METRO PLANNING COMMITTEE OF THE TOWN PLANNING BOARD

MPC Paper No. 10/16

**Submission for Compliance with
Approval Condition (a) of Application No. A/K20/126**

**Proposed Public Utility Installation (Dry Weather Flow Interceptor)
in “Open Space” Zone and area shown as ‘Road’
Government Land, Hoi Fai Road, Tai Kok Tsui, Kowloon West**

Figure 1 (Revised Design)

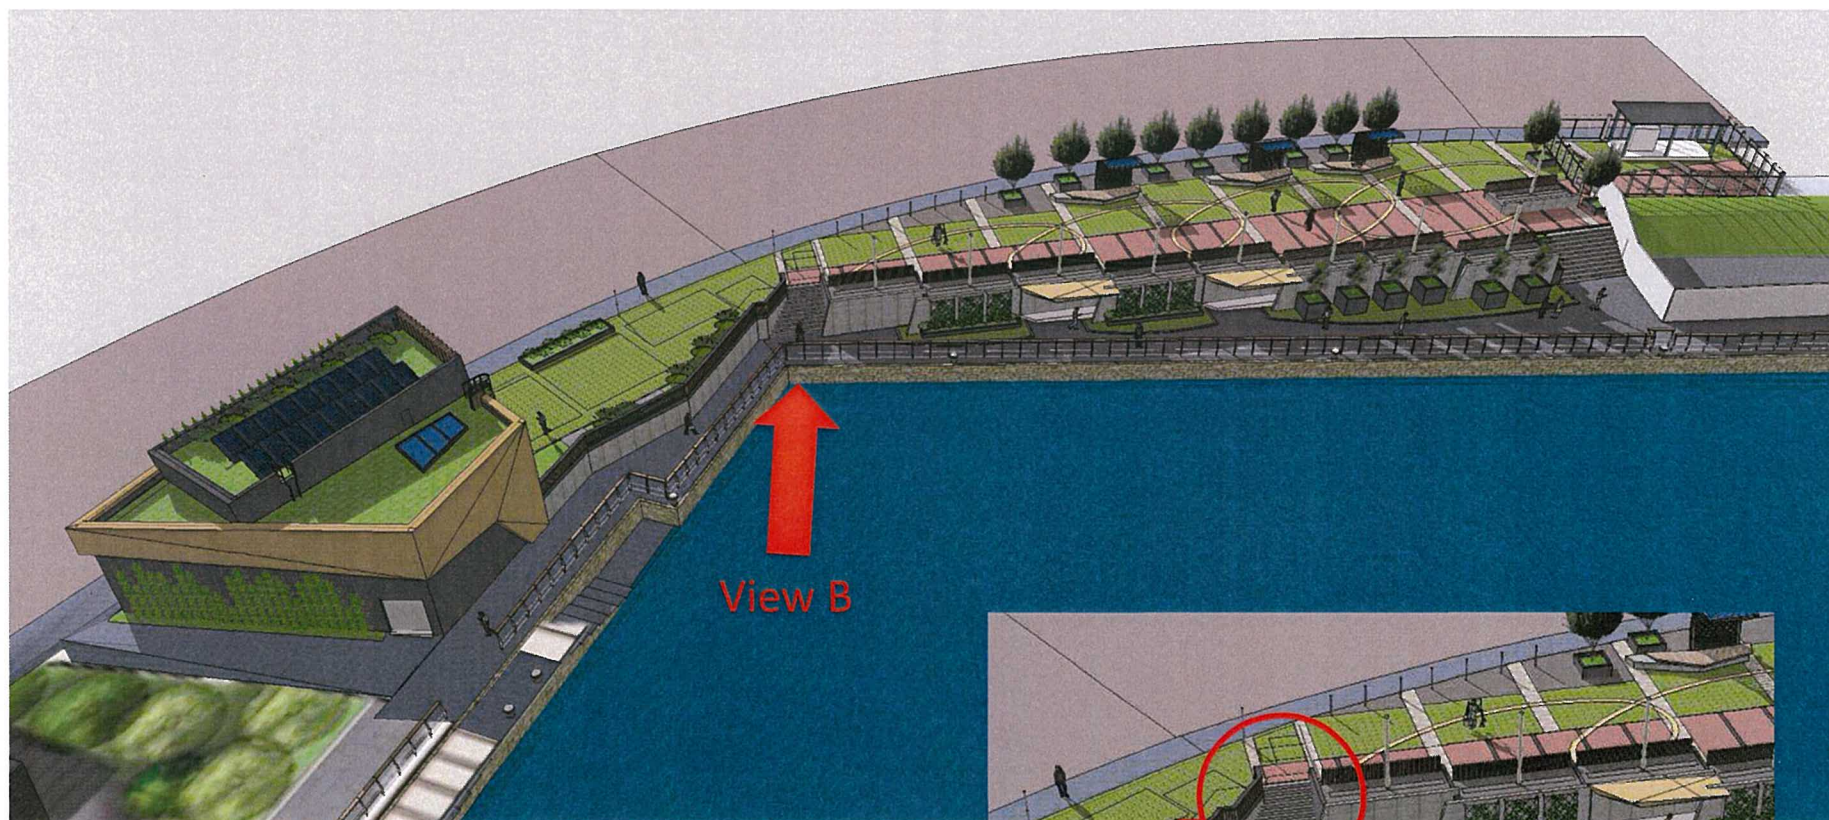
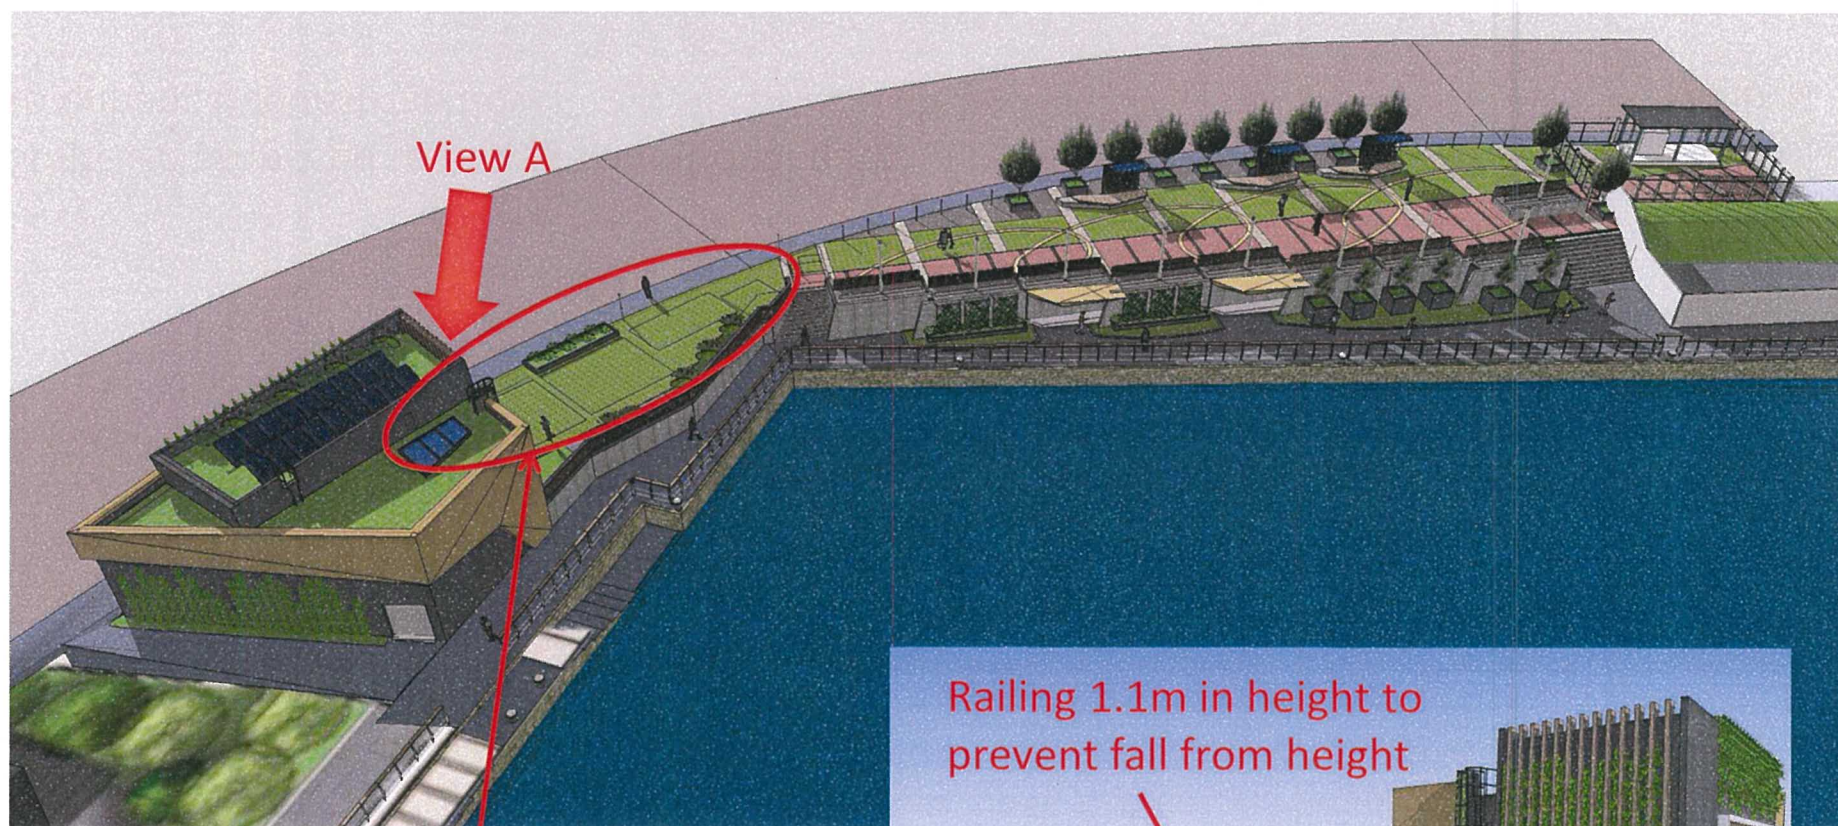
- i. We have opened up more space for the public enjoyment. One of our overall design goals is to maximize the open space for public use and improve the amenity of the vicinity. We have located most of our facilities underground except for the flood sensitive components of the pumping station, including the switch room, the dangerous goods room, the transformer room and the deodorizer room which have to be located above ground due to safety and other requirements. We have now removed the fence wall at the pumping station maximizing the provision of open space and now approximately 90% of our site area is open to public. Due to operational needs and inadequate space/soil depth for tree planting at the newly opened up area, a removable planter with shrubs was added to improve the streetscape and amenity of the vicinity. Please refer to **Figure 1** for the revised layout.

Removable planter with shrubs added to improve the streetscape and amenity of the vicinity

Figure 2 (Revised Design)

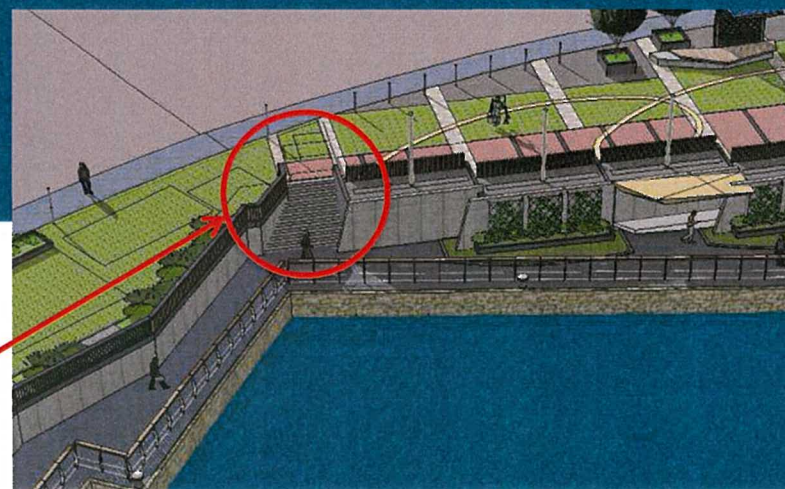
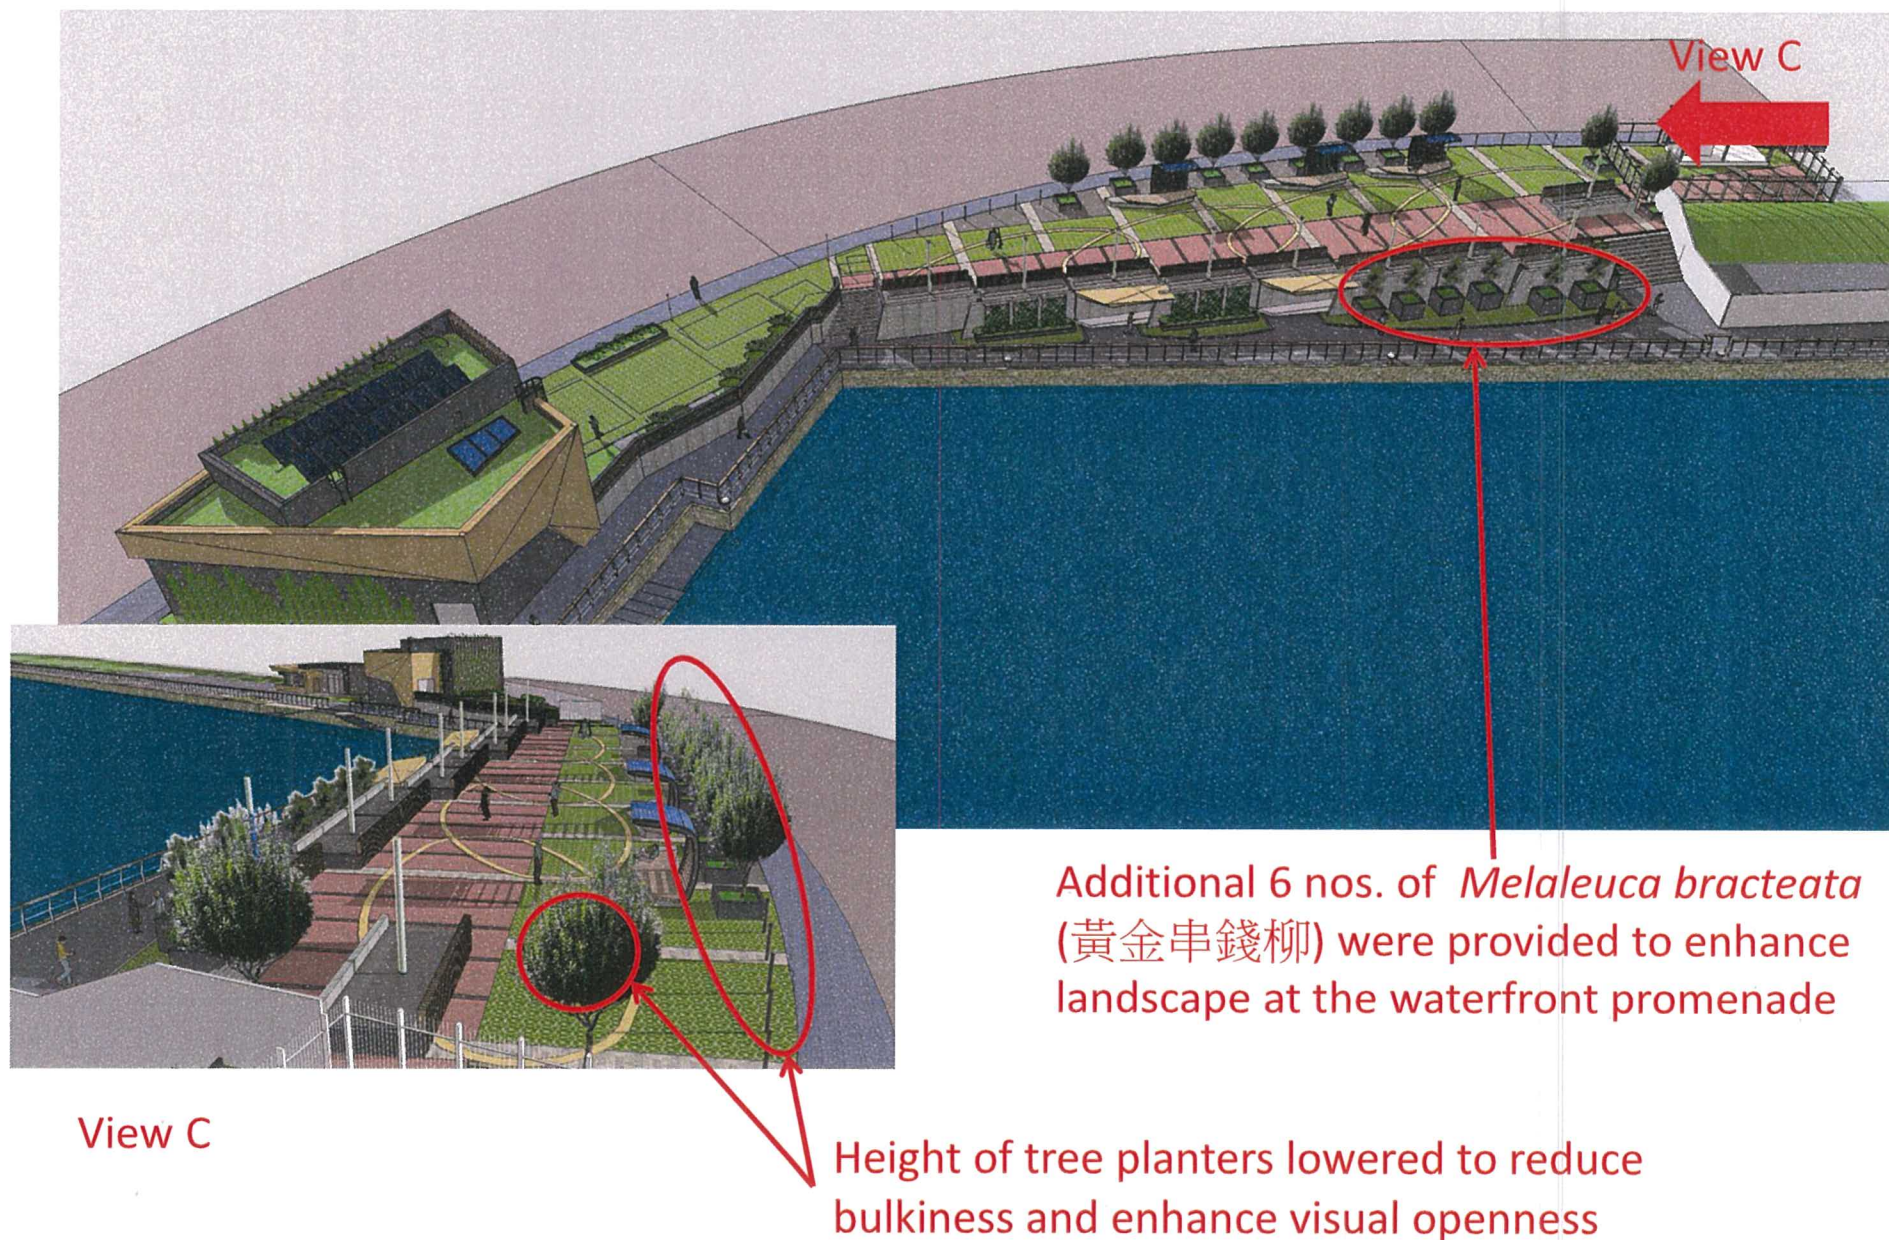
- ii. We have added a staircase to provide an additional path for pedestrians walking along the promenade to get to the open space at Hoi Fai Road to enhance pedestrian flow which will have an effect similar to the widening of the promenade. We have reviewed and found that further widening of the promenade is not achievable due to site configuration and the need to accommodate the pumping station and all the underground facilities. The proposed staircase is shown in **Figure 2**.

Staircase proposed to provide additional path
to enhance pedestrian flow

Figure 3 (Revised Design)

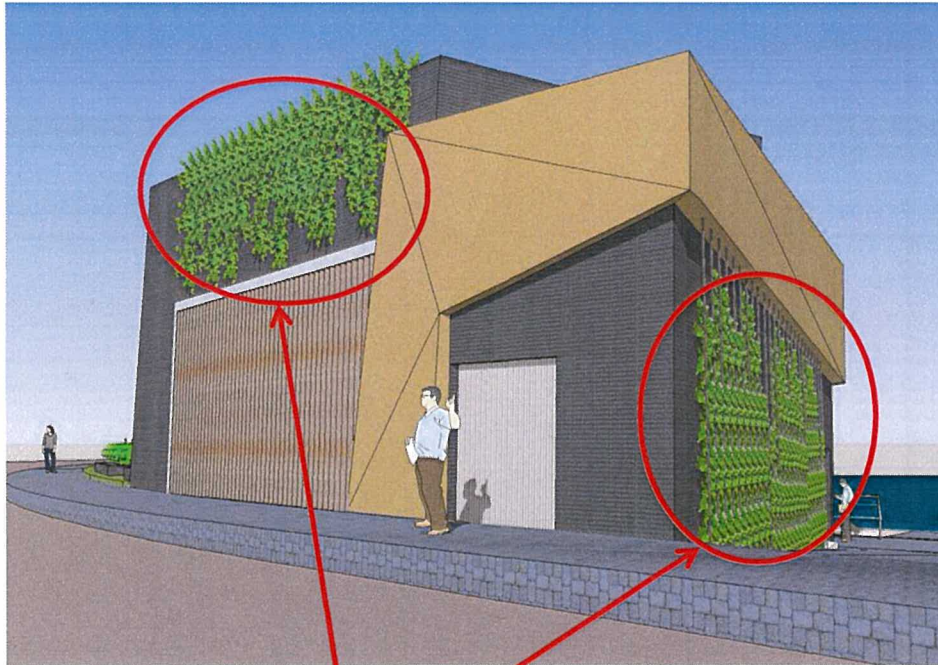
- iii. We have taken the advice of Architectural Services Department and reduced the height of the removable tree planters in the open area from 1.5m to 0.75m to enhance visual openness. The reduction of height of the planters is shown in **Figure 3**.

- v. To accord with the Town Planning Board's view and as suggested by Planning Department, we have provided 6 additional of *Melaleuca bracteata* (黃金串錢柳) towards the southern side of the waterfront promenade to enhance the landscape. The proposed additional trees are shown in **Figure 3**.

Figure 4 (Revised Design)

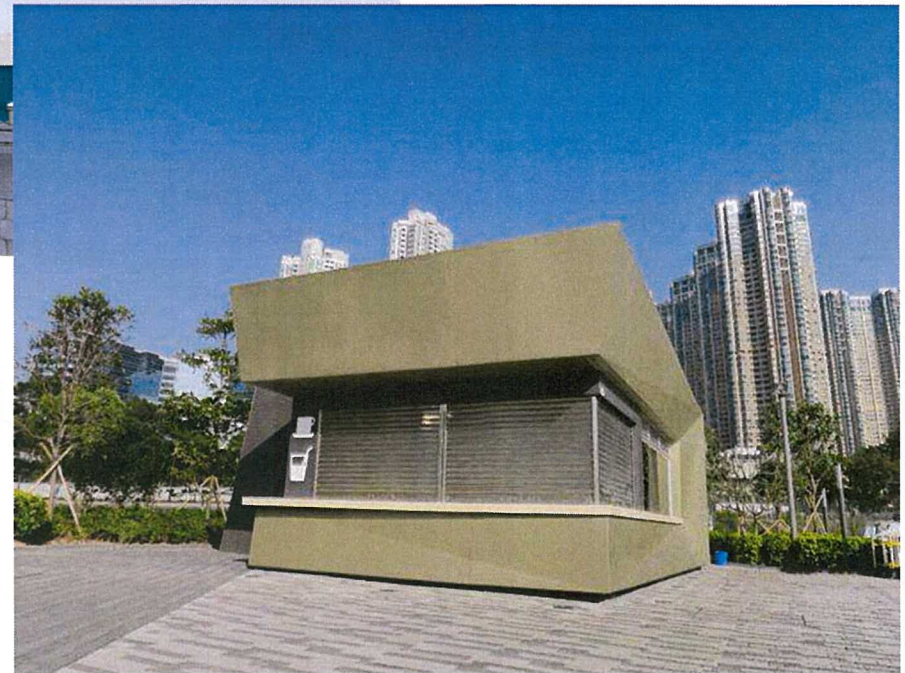
- iv. As suggested by Architectural Services Department, we have provided additional vertical greenings at the northern and western façade of the pumping station to further soften the building mass. The additional vertical greening is shown in **Figure 4**.

Vertical greening is added on the northern and western façade of the building
